Charlotte Department of Transportation

Memorandum

Subject: Rezoning Petition 15-014: Approximately 4.66 acres located on the northeast corner at the intersection of Park Road and Sharon Road (**Revised 2/13/15**).

Figure 1

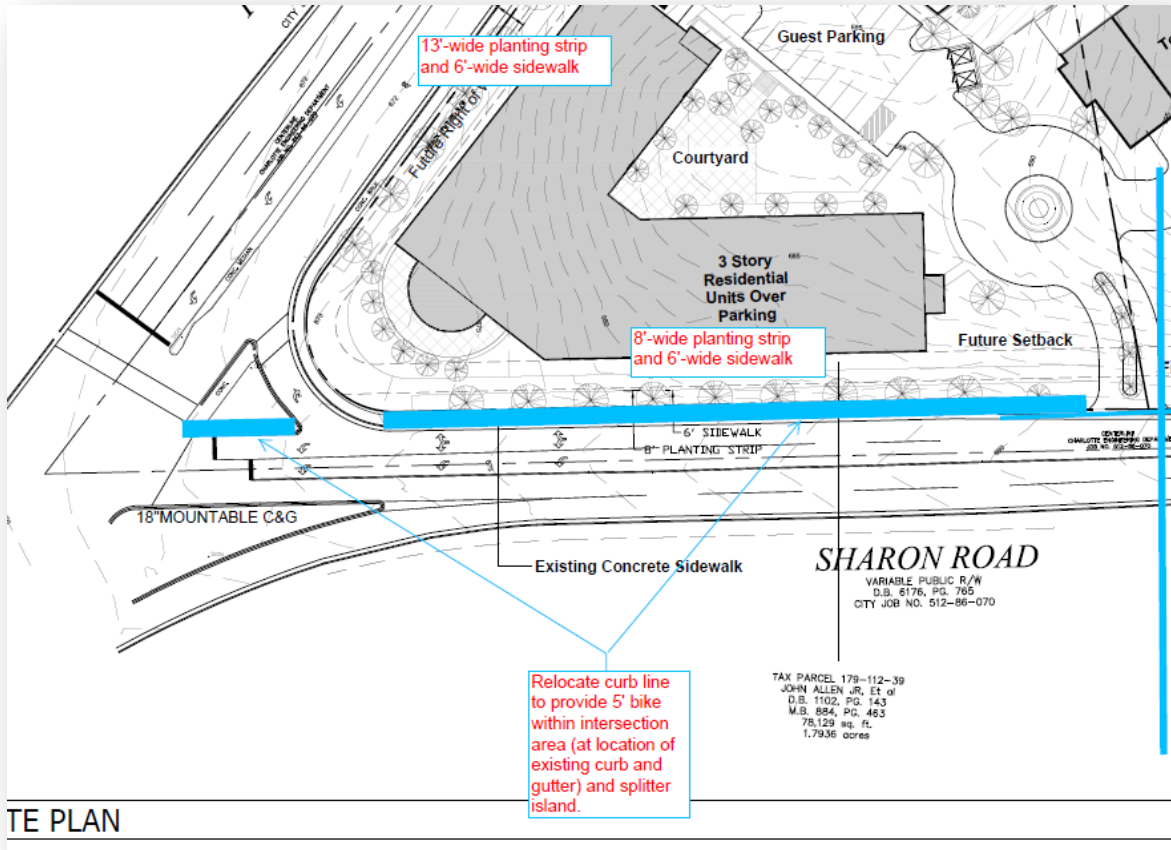
1. Sharon Road has an Urban Street Design Guidelines (USDG) classification of Avenue. The future curblines of Sharon Road should accommodate three 11-foot travel lanes and two 5-foot bicycle lanes (43 total feet of pavement width), with an 8'-wide planting strip and 6'-wide sidewalk. Please revise the plan view with dimensions and notes, and revise Transportation notes to reflect the following improvements along the site's Sharon Road frontage.

- a. At the intersection of Park Road along Sharon Road within the existing splitter island, relocate the curb line to create a 5'-wide bicycle lane.
 - b. Along the existing site's frontage where curb and gutter is present, relocate the curb line to create a 5'-wide bicycle lane.

- c. Establish the new back of curb location at 24' from centerline where curb and gutter does not exist.
 - d. Along the entire Sharon Road frontage, establish an 8'-wide planting strip and 6'-wide sidewalk.

See the Figure 1 and Figure 2 below.

Figure 3

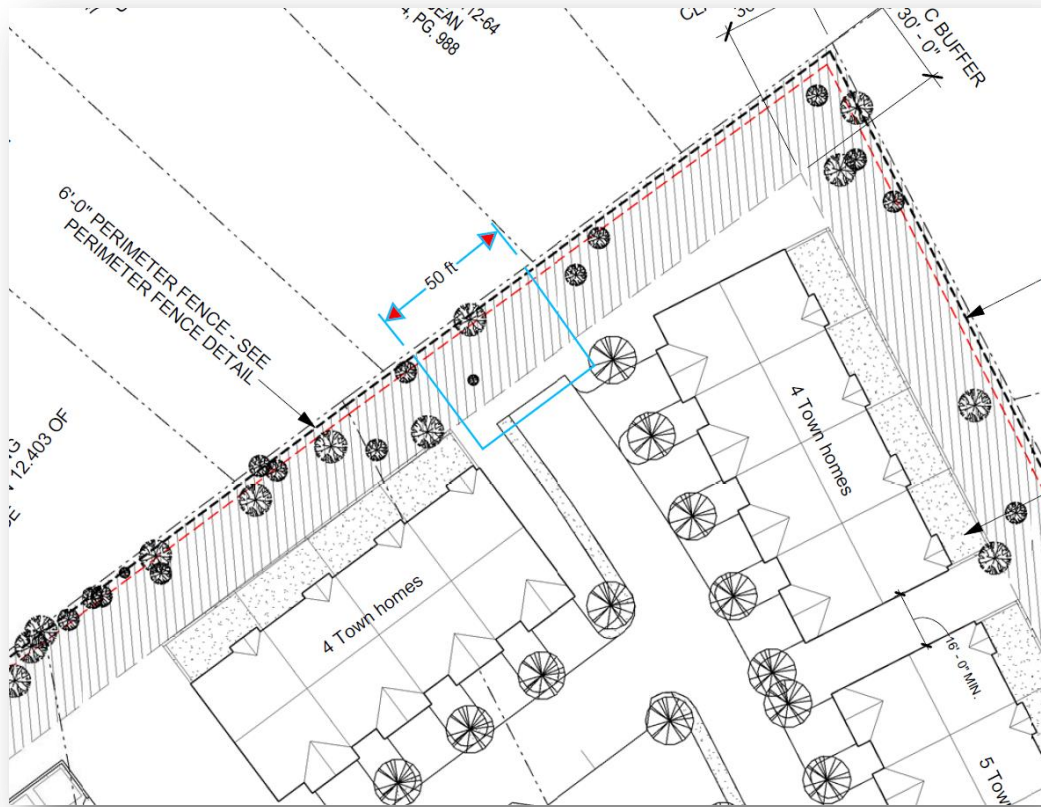
3. CDOT requests that the petitioner revise the site plan to include dedication of a minimum 50'-wide easement in which the internal private street can be extended at a future date should the parcels to the north redevelop. See Figure 3 below.
